UM O 7 2004 E UNITED STATES PATENT AND TRADEMARK OFFICE

Serial no. 09/750,765

For: METHOD AND APPARATUS

NOTICE OF COMPLIANCE BY APPELLANT

Figure 7

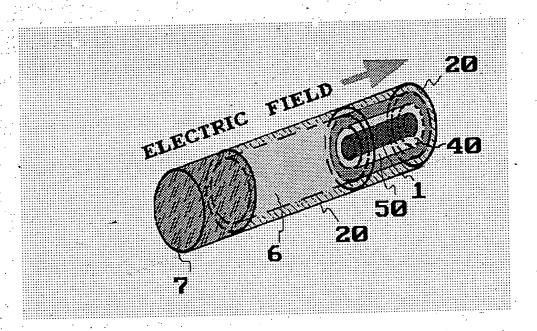
This statement by the examiner is minimizes the scope of the differences bet veen Westfall and the present invention. In the present invention, Figure 7 of the original specification, absolutely shows features which are not found in Westphal. For example, attention is directed to the four concentric components of the device surrounding the cathode, in coaxial fashion, including the deuteron diffusion barrier (labeled 50) and the expansion barrier (labeled 40). Where are they in Westphal? Attention is directed to the heavy water-LiOD-gel, labeled 6. Where is it in Westphal? Attention is directed to the device in Figure 7 shaped like a fuse, which "can be easily placed into, or removed from, an assembly and system". Where is it in Westphal?

This statement by the examiner is minimizes the scope of the differences between Kinsella and the present invention. In the present invention, Figure 7 of the original specification, absolutely shows features which are not found in Kinsella. For example, attention is directed to the four concentric components of the device surrounding the cathode, in coaxial fashion, including the deuteron diffusion barrier (labeled 50) and the expansion barrier (labeled 40). Where are they in Kinsella? Attention is directed to the heavy water-LiOD-gel, labeled 6. Where is it in Kinsella? Attention is directed to the device in Figure 7 shaped like a fuse, which "can be easily placed into, or removed from, an assembly and system". Where is it in Kinsella?

This statement by the examiner is false. This statement by the examiner is minimizes the scope of the differences between Patterson and the present invention. In the present invention, Figure 7 of the original specification, absolutely shows features which are not found in Patterson. For example, attention is directed to the four concentric components of the device surrounding the cathode, in coaxial fashion, including the deuteron diffusion barrier (labeled 50) and the expansion barrier (labeled 40). Where are they in Patterson? Attention is directed to the heavy water-LiOD-gel, labeled 6. Where is it in Patterson? Attention is directed to the device in Figure 7 shaped like a fuse, which "can be easily placed into, or removed from, an assembly and system". Where is it in Patterson?

Figure 11

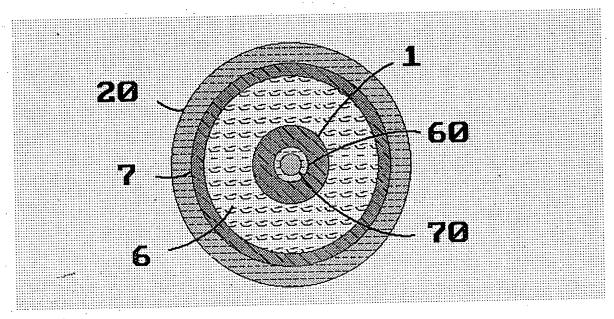
In the present invention, Figure 11 shows features which are not found in Westphal. For example, attention is directed to the coaxially-filled cathode, the inner coaxial deuteron-barrier and thermal pipe in a cylindrical configuration, the electric fields in the radial direction, and the anode which is circumferential to the cathode [labeled 7]. Where are they in Westphal? Figure 11 shows solution (labeled 6) which consists of lithium deuteroxide, palladium deuteroxide, and heavy water as the preferred embodiment. Where is it in Westphal?

In the present invention, Figure 11 shows features which are not found in Westphal. For example, attention is directed to the coaxially-filled cathode, and thermal pipe in a cylindrical configuration, and the anode which is circumferential to the cathode [labeled 7]. Where are they in Westphal?

In the present invention, Figure 11 shows features which are not found in Kinsella. For example, attention is directed to the coaxially-filled cathode, the inner coaxial deuteron-barrier and thermal pipe in a cylindrical configuration, the electric fields in the radial direction, and the anode which is circumferential to the cathode [labeled 7]. Where are they in Kinsella? Figure 11 shows solution (labeled 6) which consists of lithium deuteroxide, palladium deuteroxide, and heavy water as the preferred embodiment. Where is it in Kinsella?

In the present invention, Figure 11 shows features which are not found in Patterson. For example, attention is directed to the coaxially-filled cathode, the inner coaxial deuteron-barrier and thermal pipe in a cylindrical configuration, the electric fields in the radial direction, and the anode which is circumferential to the cathode [labeled 7]. Where are they in Patterson? Figure 11 shows solution (labeled 6) which consists of lithium deuteroxide, palladium deuteroxide, and heavy water as the preferred embodiment. Where is it in Patterson?

Figure 13

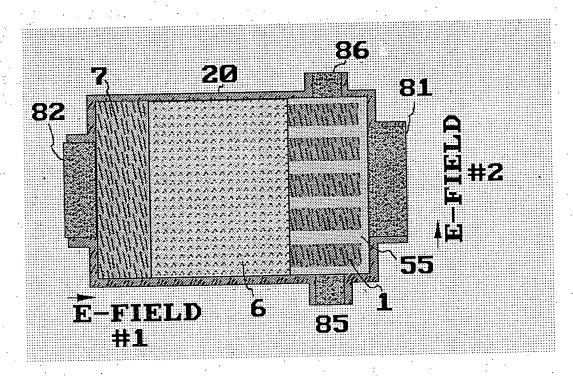
In the present invention, Figure 13 shows features which are not found in Westphal. For example, attention is directed to the lamellar CAM reactor, the two orthogonal applied electric fields, the connections for the first electric field labeled as 81 and 82, the connections for the second electric field labeled as 85 and 86, the mechanical casing labeled 20, and the deuteron impermeable barrier which is comb-shaped in this preferred configuration, and is labeled 55 in Figure 13. Exactly where are any of these in Westphal?

In the present invention, Figure 13 shows features which are not found in Kinsella. For example, attention is directed to the lamellar CAM reactor, the two orthogonal applied electric fields, the connections for the first electric field labeled as 81 and 82, the connections for the second electric field labeled as 85 and 86, the mechanical casing labeled 20, and the deuteron impermeable barrier which is comb-shaped in this preferred configuration, and is labeled 55 in Figure 13. Exactly where are any of these in Kinsella?

In the present invention, Figure 13 shows features which are not found in Patterson. For example, attention is directed to the lamellar CAM reactor, the two orthogonal applied electric fields, the connections for the first electric field labeled as 81 and 82, the connections for the second electric field labeled as 85 and 86, the mechanical casing labeled 20, and the deuteron impermeable barrier which is comb-shaped in this preferred configuration, and is labeled 55 in Figure 13. Exactly where are any of these in Patterson?
